18/04240/FU

Application Number: 18/04241/LBC

Address: The Summer House Green Lane Chedworth CHELTENHAM Gloucestershire GL54 4AP

Proposal: Alterations and enlargement of the existing dwellinghouse and a two storey side extension

KEY TO MAP

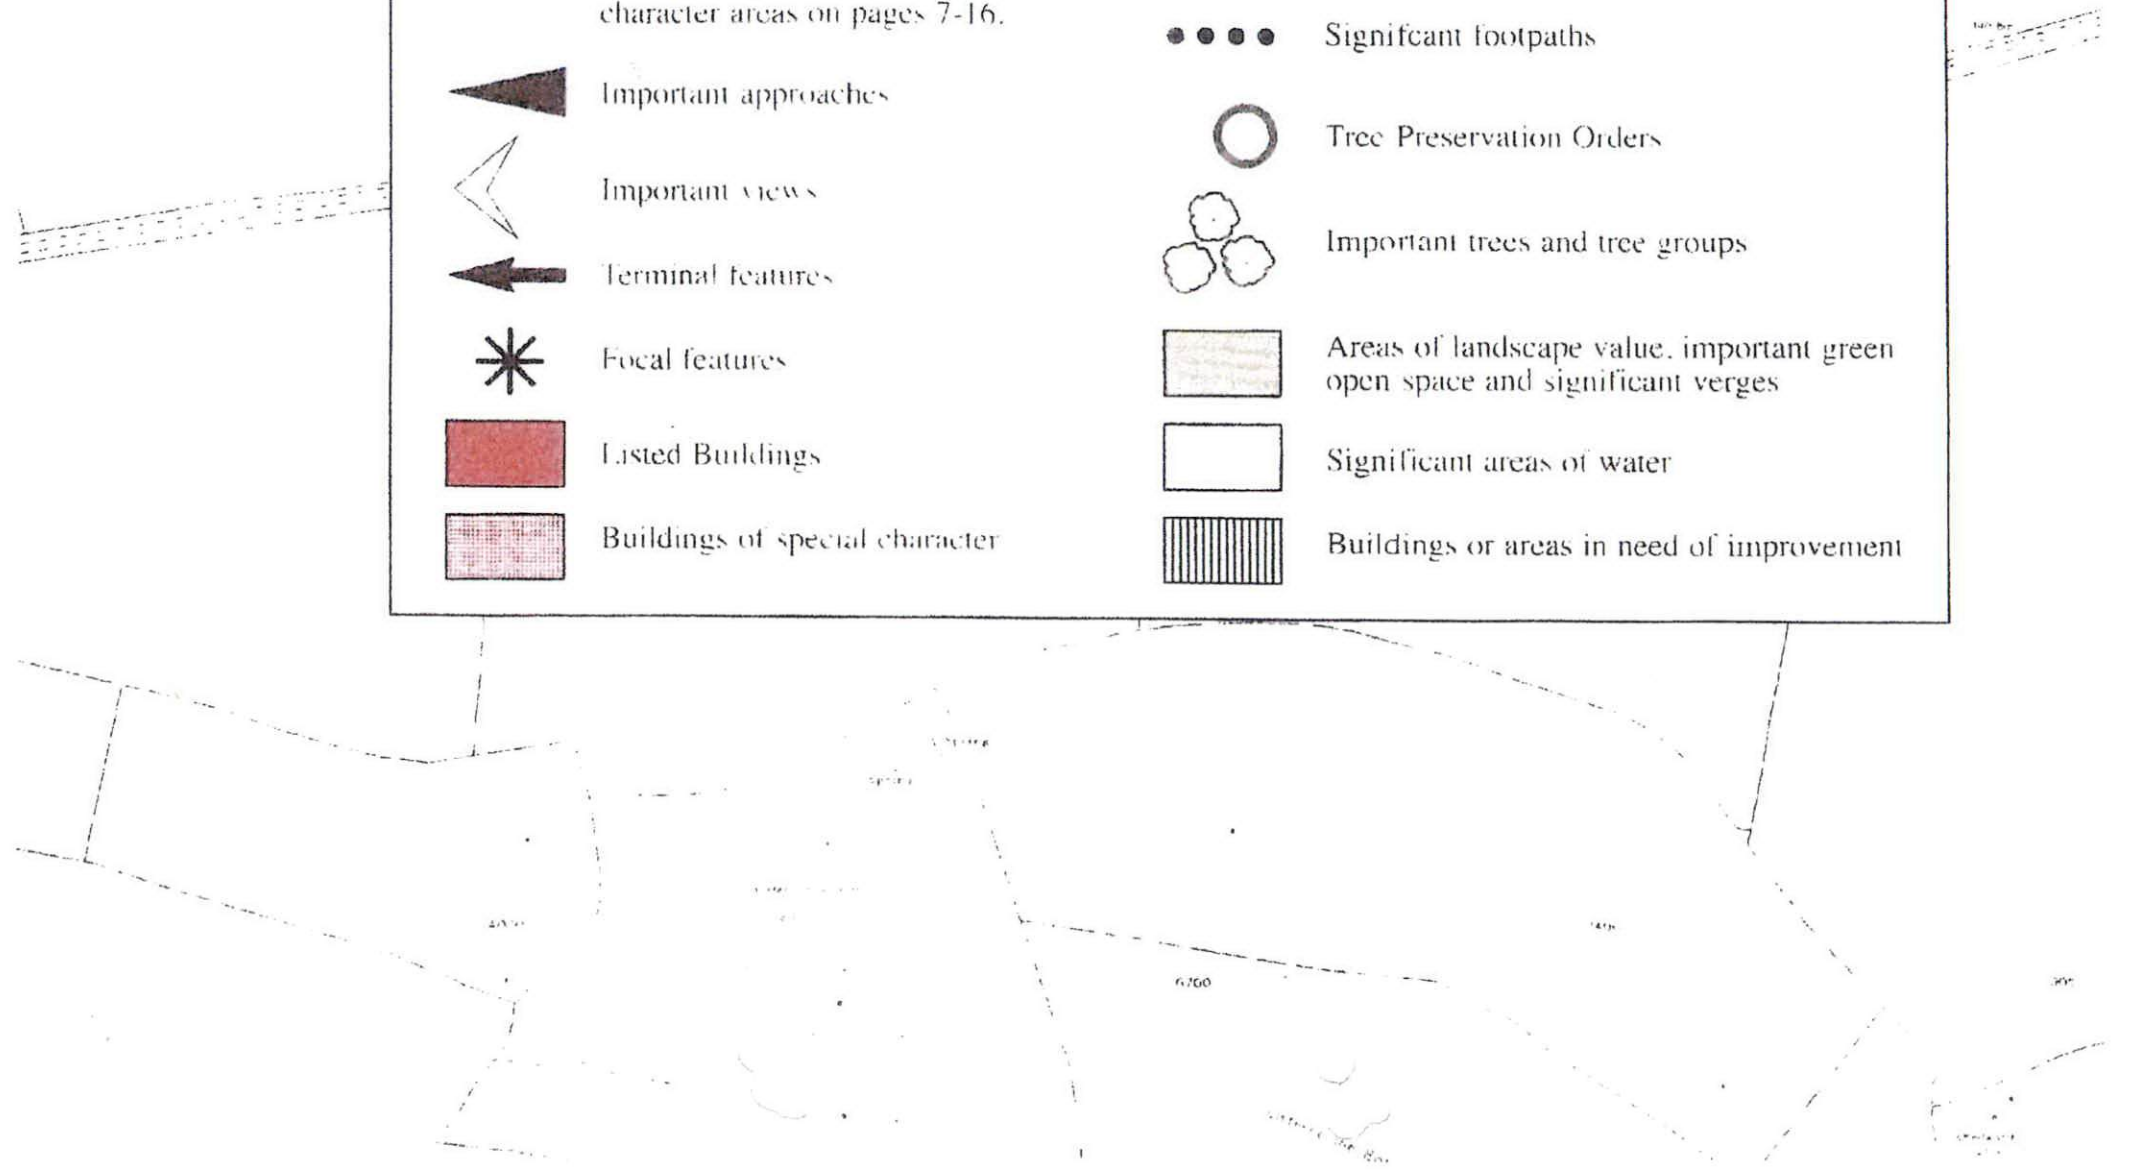
The report refers to the proposed extension being within the existing domestic curtilage of the site. This is not correct. I have previously referred you to an extract of the Chedworth Conservation Area Plan which clearly shows that the extension encroaches into an "Area of landscape value, important green space and significant verges" as well as a boundary defined on the same Plan as "important hedges, walls and banks." Marked with a red line. The Plan also highlights the fact that the proposed extension is central to an "important view" identified on the southern side of the valley which will inevitably be impacted adversely. All three of these are important material considerations in terms of the statutory protection afforded to this property which you have not referred to in your report. Having regard to these facts, the proposal must cause harm to the Conservation Area as well as the Designated Heritage Asset. I have attached the same Plan extract for ease of reference.

Examples of Roof Pitches on a Modern Housing Estate in Cirencester

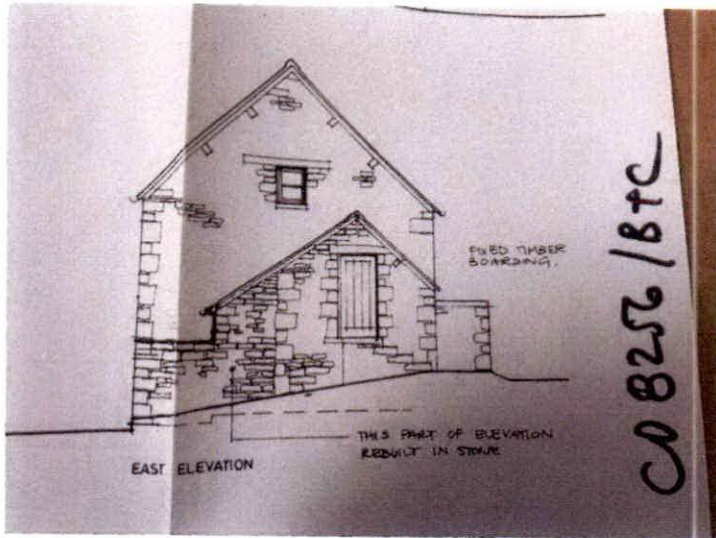
The report refers to the shallow pitch of the proposed extension being acceptable having regard to the existing form of the roof. No mention is made of the original roof pitch of both the main barn building and the former side extension. Nor is any mention made of previous attempts to reduce the pitch of the roof to the side extension which to date have been resisted/refused by the Planning Authority. I have taken the opportunity of attaching an illustration of the key elevation, as existed at the point of the barns' initial conversion and as is now proposed. I have also attached photos of the roofs that can be seen on any new build housing estate around the Cotswolds. As can be seen, all of the roof pitches are consistent with the Cotswolds Design Code notwithstanding the fact they are not Designated Heritage Assets, not in a Conservation Area and not in an Area of Outstanding Natural Beauty. I fail to see how such a shallow roof pitch can be deemed acceptable with this application, given all the statutory policies that exists to protect it.
